Morris Goding
Access Consulting

60-70 Horace Street, St. Ives -
St. Ives Indoor Sports
Complex

**Access Review –
DA Final v3**

25 October 2021

GROUND FLOOR PLAN
Scale: 1:150 @A1 Date: 10/06/2021
Drawn: JA Checked: KM

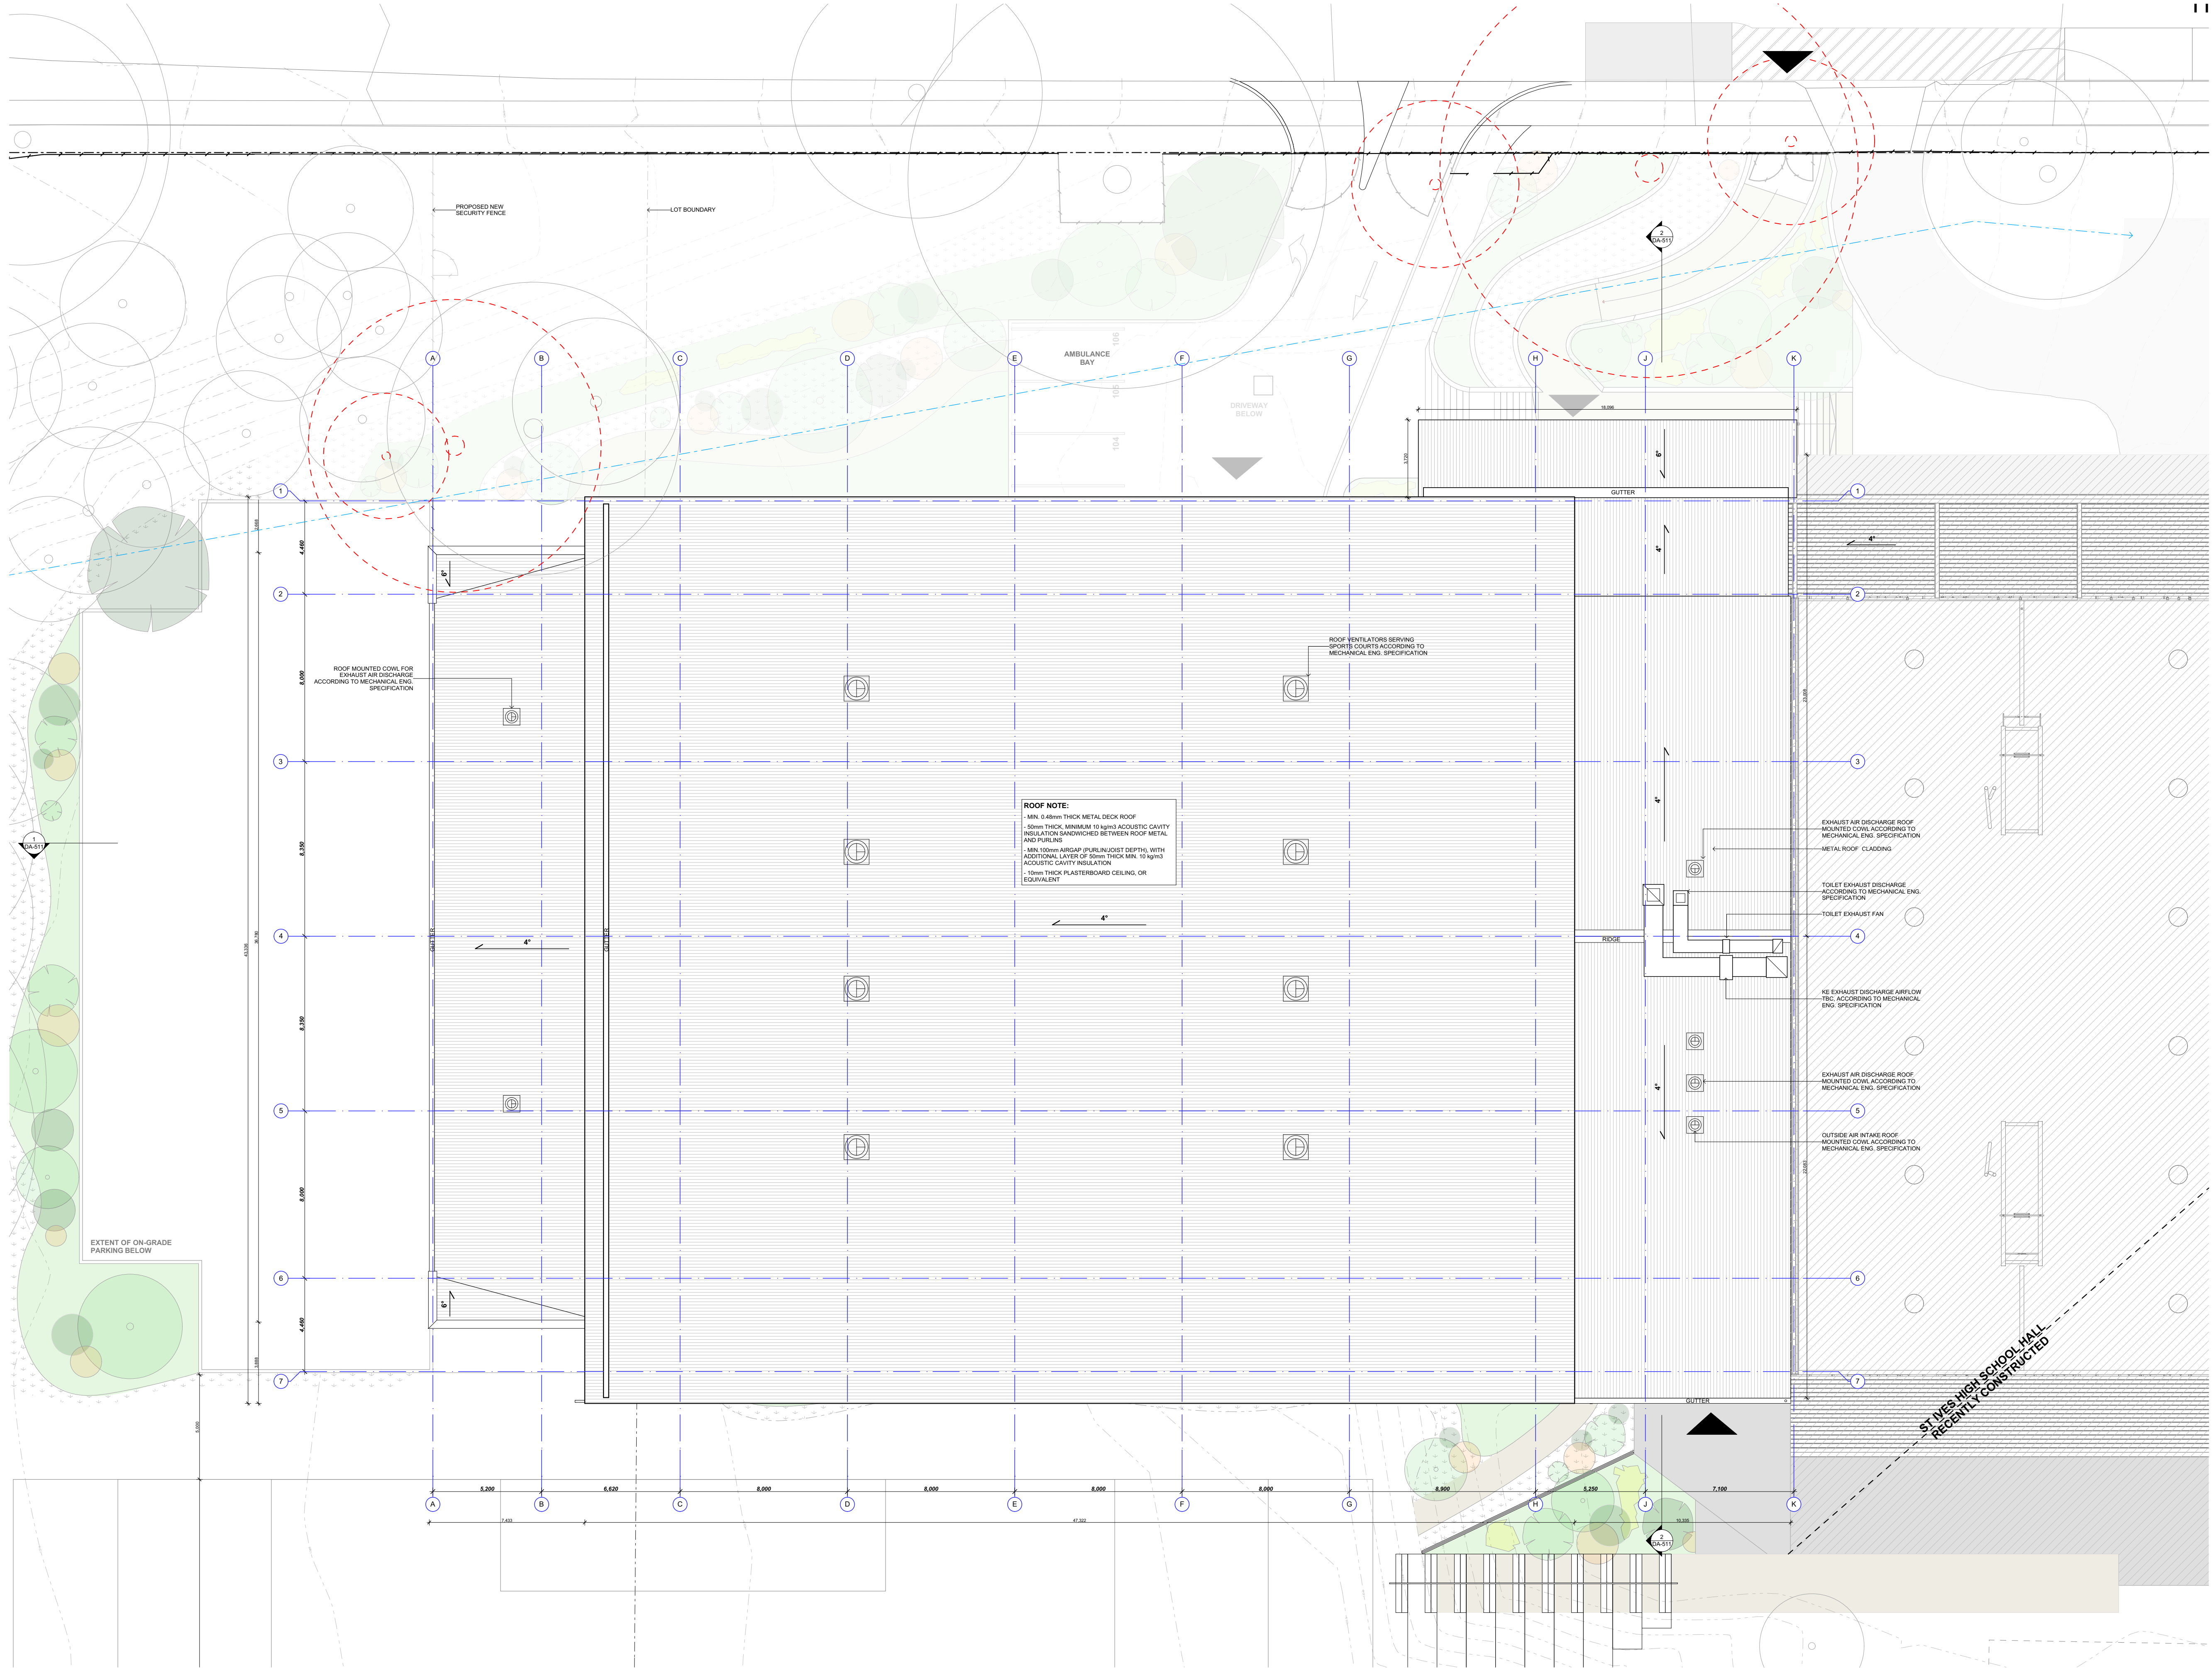
Wheelchair seating to be provided as per AS1428.1 and DDA Premises Standards

Number seating spaces to be provided to determine number of accessible seating

Threshold level required(all doors) 14,4500RL

Stair details to be reviewed at later design stages (TGSI's, handrails etc)

Directional signage indicating the accessible path of travel at later design stages to be provided (top of stair)

It is understood that it will be a continuous accessible path of travel (CAPT) from the top of stairs/bleach seating to the existing building compliant with AS1428.1:2009. The connection will address the level difference.

Can be resolved at later design stages

Can be resolved at later design stages
